DESIGN <i>BS</i>	DRAWN BY <i>BS</i>	DART AEROSPACE LTD HAWKESBURY, ONTARIO, CANADA		
CHECKED <i>PH</i>	APPROVED <i>HH</i>	DRAWING NO. DSI 9350	REV. A	SHEET 1 OF 2
DATE 06.08.22		TITLE INLET/OUTLET ADAPTERS RELOCATION	SCALE NTS	
A	06.08.22	NEW ISSUE

## DART SERVICE INSTRUCTION

TO AMEND INSTALLATION INSTRUCTIONS IIN-D206-746 REV.A

REF. CANADIAN STC: SH05-45 ISSUE 1

### RELOCATION OF D3478-041 AIR INLET ADAPTER

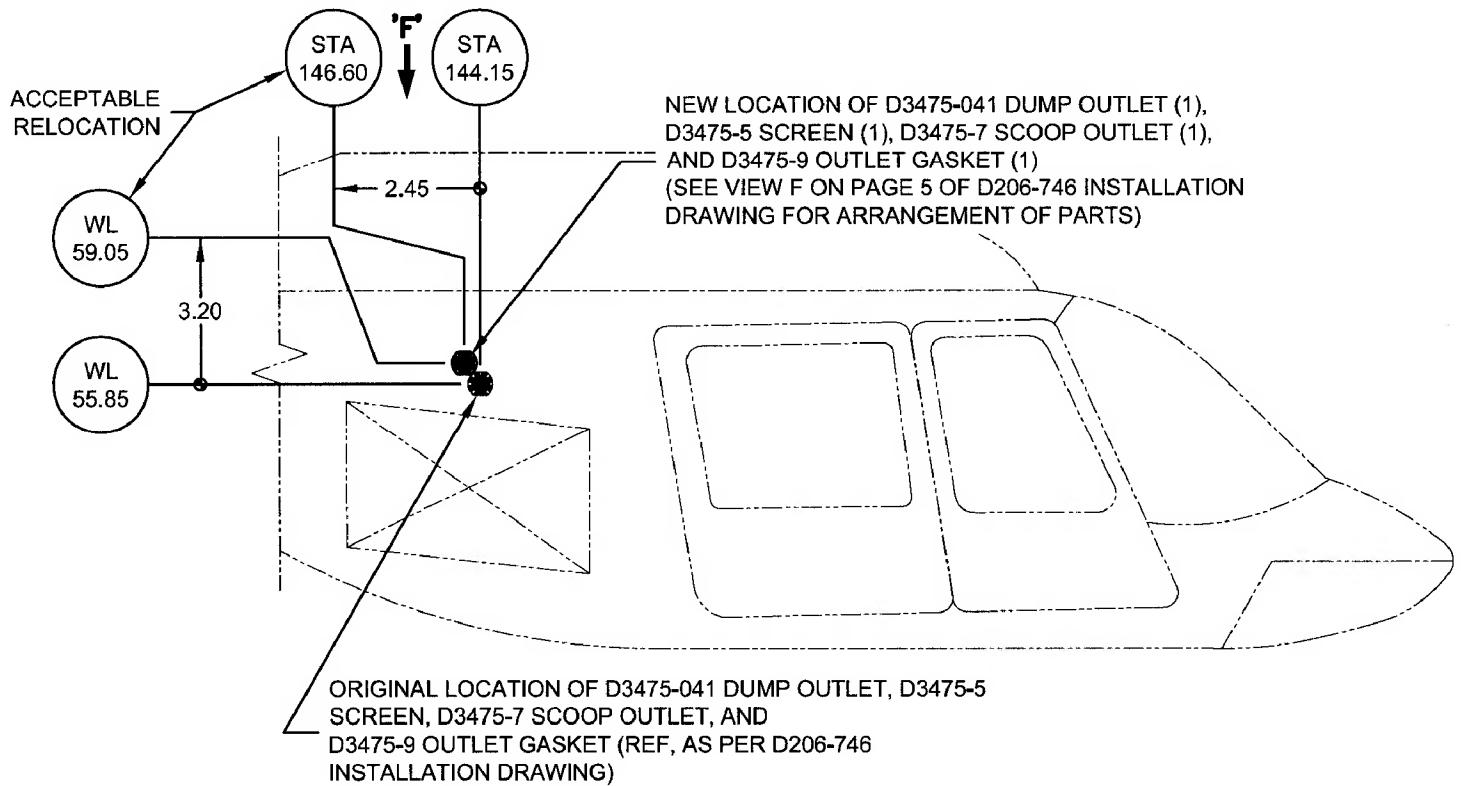
IT IS ACCEPTABLE TO CHANGE THE LOCATION OF THE D3478-041 AIR INLET ADAPTER FROM STA 137.40 AND WL 61.00 (SEE D206-746 INSTALLATION DRAWING PAGE 1) TO STA 148.50 AND WL 66.00 AS SHOWN BELOW.

IT MIGHT BE NECESSARY TO TRIM THE SCREW THAT CONNECTS FROM THE D3478-041  
INLET ADAPTER INSTALLATION TO D3469-041 SHUT-OFF VALVE ASSEMBLY.
